E4356A-02A

S E R V I C E N O T E

**E4356A TELECOM DC OWER SUPPLY GPIB
CONTROLLED**

**The Current Shunt (Circuit Reference “R907”) may have intermittent sense
wires, which may cause Instability of Current regulation, Current read back and
current programming.**

A6 Output Assembly for Models (65/6673A, 74A, 75A & E4356A)

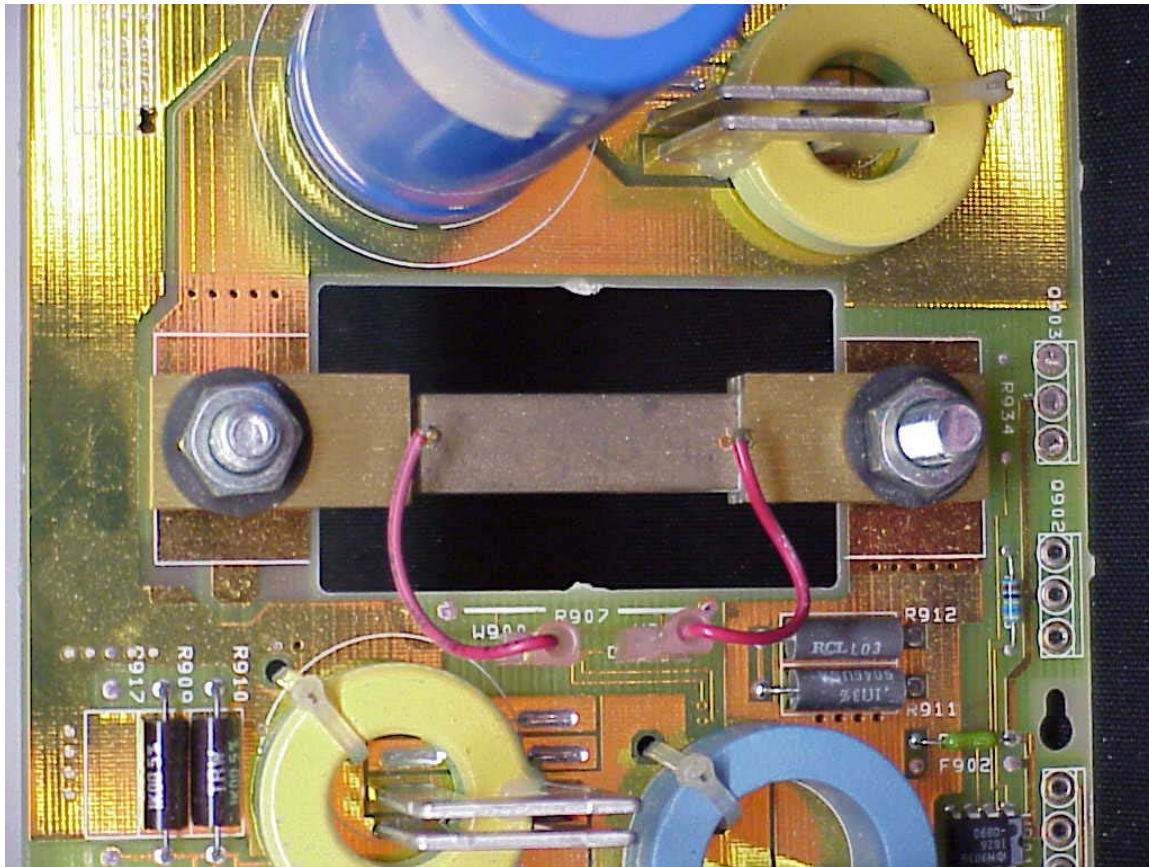
When the push-on connectors become intermittent the output current will become unstable. Loose push-on connectors can cause the output current to change dramatically. The current can change from any set current, and may go to the maximum rated output current of the instrument.

This picture shows how the Shunt R907 is connected using the term-crimp connectors.

The Shunt R907 is connected to "W900" & "W901"

Cut the terminal-crimp connectors off of both wires and discard the connectors. Make this cut as close to the terminal-crimp connector as possible. The required strip length should be 5mm. This strip length will be used to prevent the wire length being too long and shorting to the instrument chassis. If replacement of this wire is required any color (22 AWG, 300V 105C) wire type can be used.

This modification can be done from the top of the board. Carefully strip and solder the wires, and avoid burning the wire insulation and the printed circuit board.

The wires should be connected as shown below. There are two holes marked R907 that should be used. Do not cross the wires when making this modification. See picture below for details. This picture shows the required modification.
